**BID NO. 24-020
GLADIATOR LAKE DRAINAGE ENHANCEMENTS**

ADDENDUM NO. 1

April 30, 2024

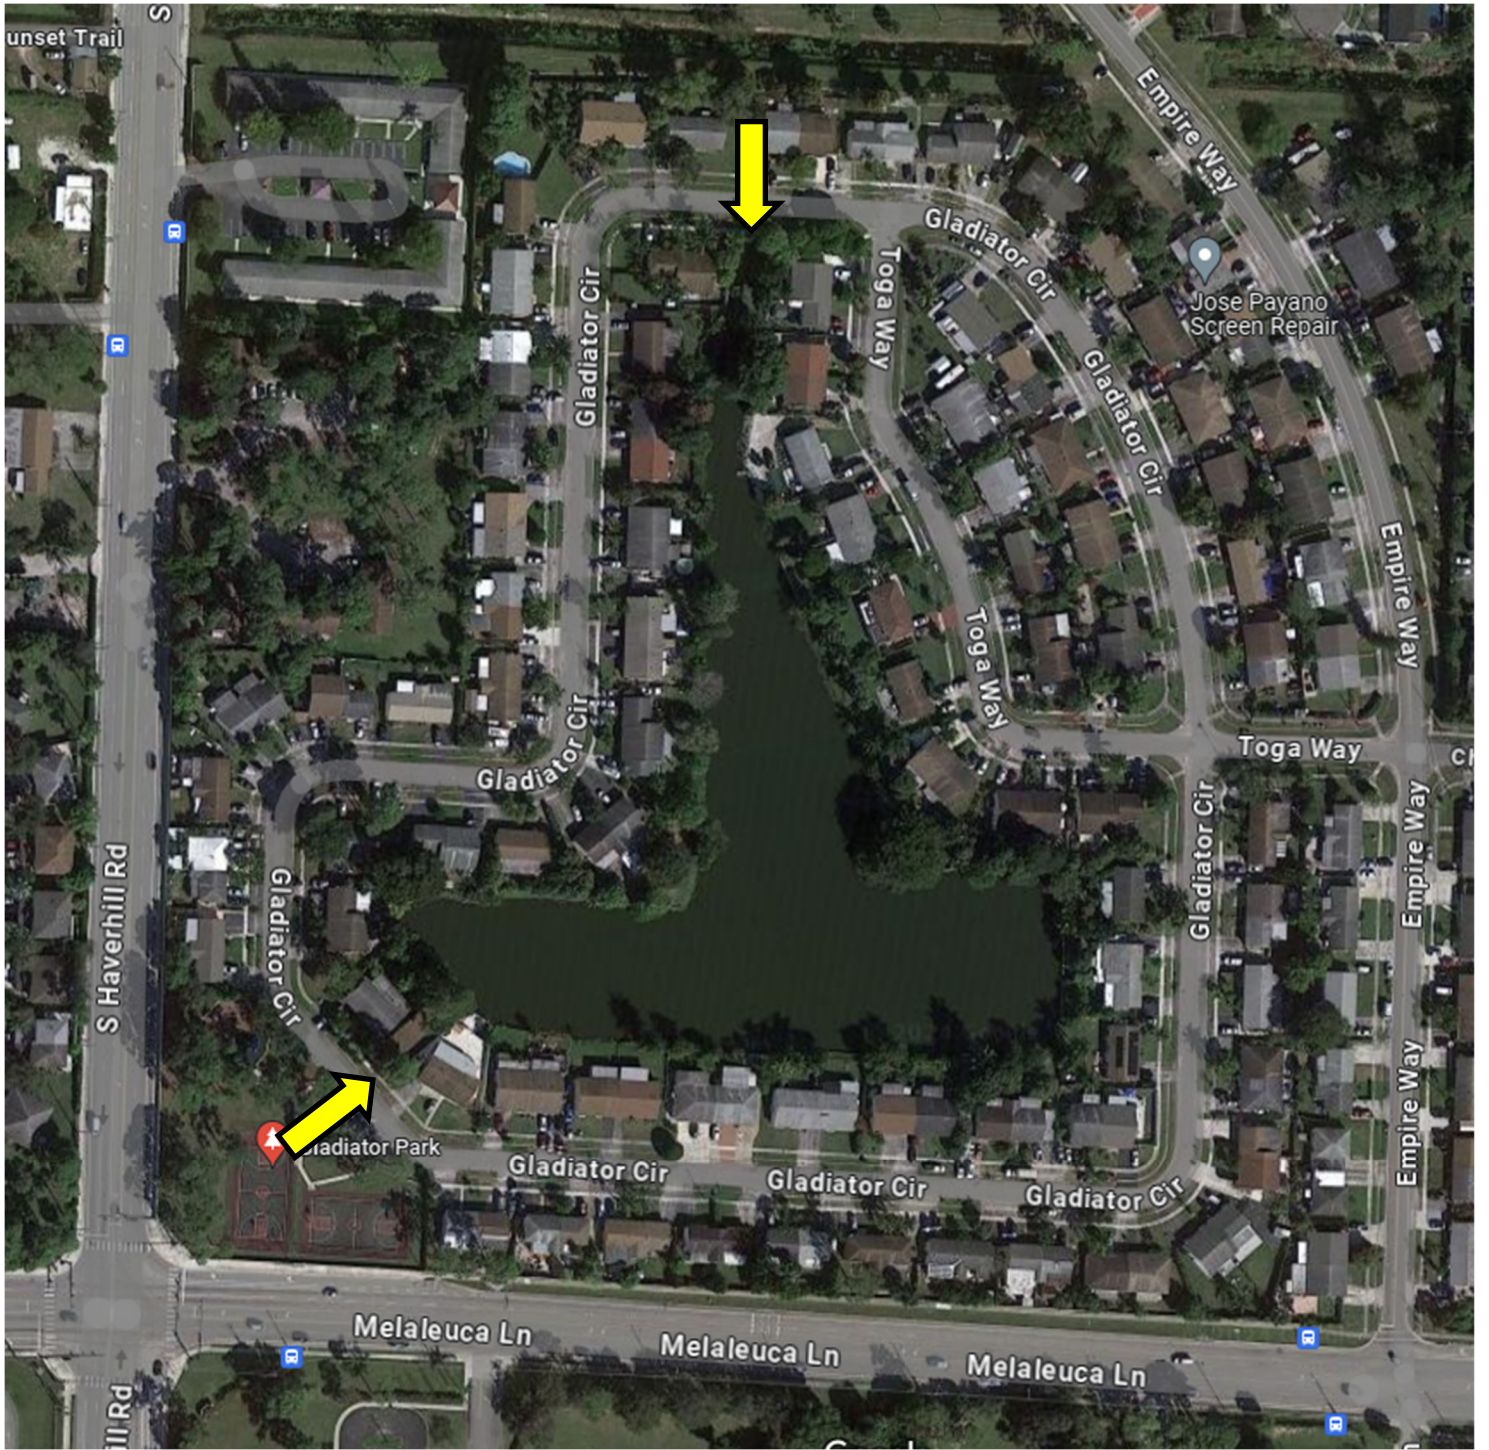
- 2. Should we call prior to visiting the site or can we go anytime?**

The site has public access and can be visited anytime. Please see attached for the map of the accessible locations.
